Access Compliance Report

Public Rights-of-Way

(Curb Ramps)

Intersection ID: 9598	Main Street: FRANK_DR	Cross Street: THE_PLAZA	Location:	NE
ADA ID: 301402EAE5ED	Ramp Type: Perp	Initial Pass/Fail: Fail	Overall Compliance: No	Severity Score: 10
Codes/Mitigation Info/Possible Solution		Field Measurements/Component Compliance

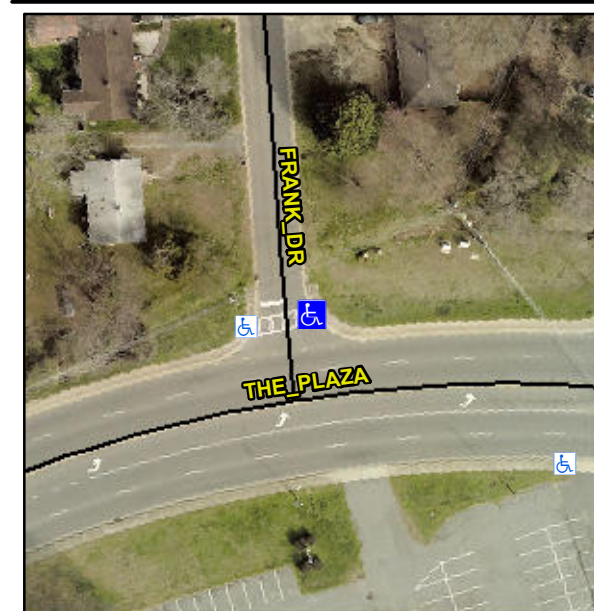
Not Found, R304.5.1, R304.5.3

Compliance	Description	Data	Compliance	Description	Data
N/A	Ramp Length (in)	62.0	Yes	Ramp Slope (%)	8.2
No	Ramp Width (in)	47.5	No	Ramp XSlope (%)	3.9
N/A	Flare Type LT	N/A	N/A	Flare Type RT	N/A
N/A	Flare Slope LT (%)	N/A	N/A	Flare Slope RT (%)	N/A
N/A	Flare Traversable LT?	N/A	N/A	Flare Traversable RT?	N/A
N/A	Landing Length (in)	N/A	N/A	DWS Provided?	N/A
N/A	Landing Width (in)	N/A	N/A	DWS Contrast?	N/A
N/A	Landing Slope (%)	N/A	N/A	DWS Length (in)	N/A
N/A	Landing X Slope (%)	N/A	N/A	DWS Full Width?	N/A
N/A	Landing Curb? (Y/N)	N/A	N/A	DWS Offset (in)	N/A
N/A	Shared Landing?	N/A			
N/A	Gutter Ponding?	N/A	N/A	Gutter Slope (%)	N/A
N/A	Gutter Lip Ht (in)	N/A	N/A	Gutter X Slope (%)	N/A
N/A	Painted X Walk1?	Yes	N/A	Painted X Walk2?	N/A
	X Walk 1 Direction	To W		X Walk 2 Direction	N/A
N/A	X Walk 1 Width (in)	87.0	N/A	X Walk 2 Width (in)	N/A
	X Walk 1 Slope (%)	2.7		X Walk 2 Slope (%)	N/A
	X Walk 1 X Slope (%)	2.4		X Walk 2 X Slope (%)	N/A

Remove & Replace Entire Ramp.
